NP-11-0010
March 23, 2011

Subject: Exelon Nuclear Texas Holdings, LLC
Victoria County Station Early Site Permit Application
Response to Request for Additional Information Letter No. 04
NRC Docket No. 52-042

RAI 03.05.01.06-1:**Question:**

Figure 1: Comparison of Current Technology Layouts with Determined Bounding Footprint Area

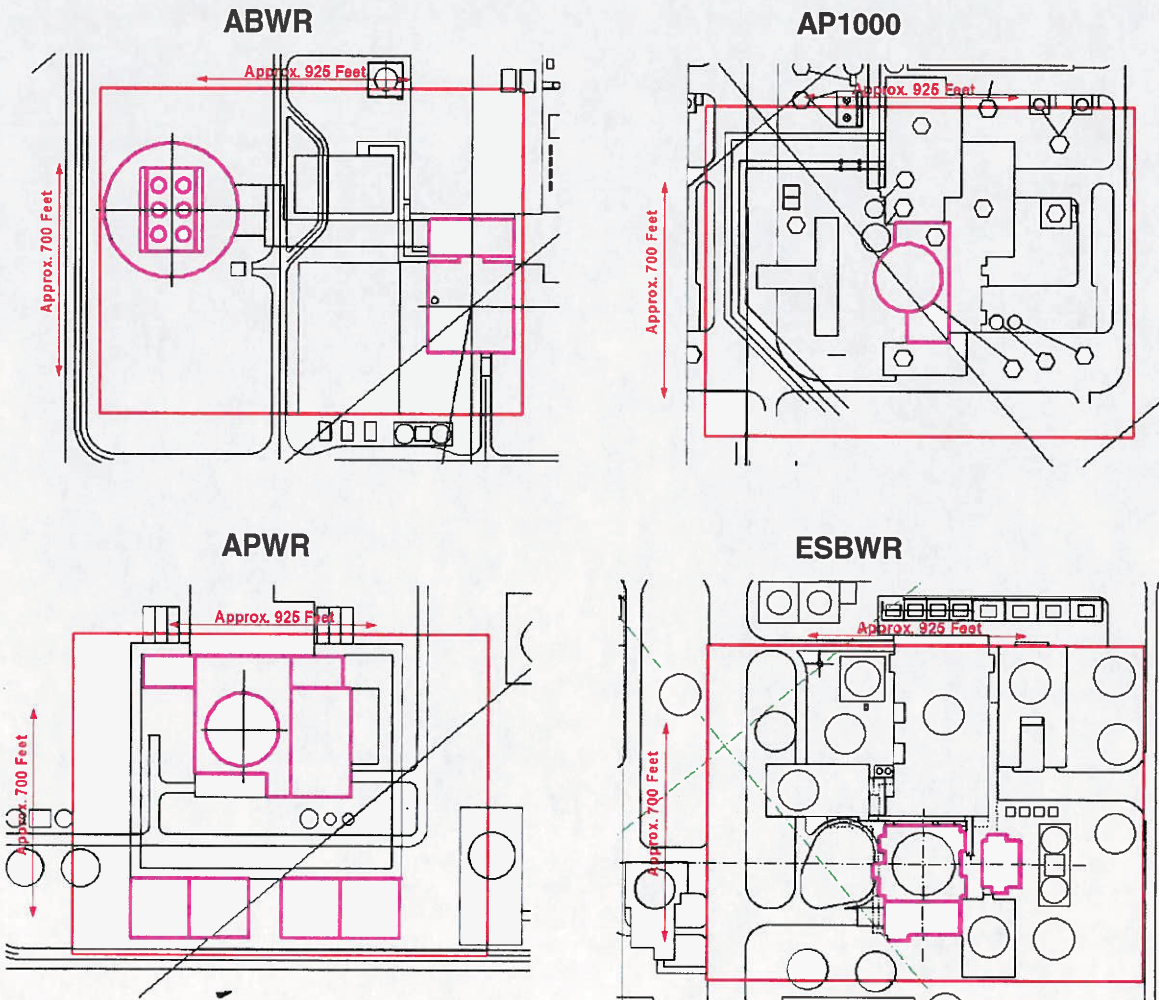
RS-002 provides guidance regarding the information that is needed to ensure that potential hazards in the site vicinity (such as airports, dams, transportation routes, military and chemical facilities) are identified and evaluated to meet the siting criteria in 10 CFR 100.20 and 10 CFR 100.21. SSAR Section 2.2.3.1.4 does not provide sufficient information for the NRC staff to perform an independent determination of aircraft impact probability. Provide the aircraft crash rate, the assumptions for effective area determination, and the parameters for aircraft crash location conditional probability (per square mile) for each aircraft type and for each flight phase used in determining the total annual aircraft crash impact probability (F).

- In analyzing the various layouts, an approximate length of 925 ft was chosen as the bounding footprint length, **L**, to encompass all current technologies. (See Figure 1)

- It should be noted, that these bounding values would be conservative for any of the current technologies—as depicted in Figure 1, there would be much open

space (or non-safety-related areas in the target area) included for these dimensions.
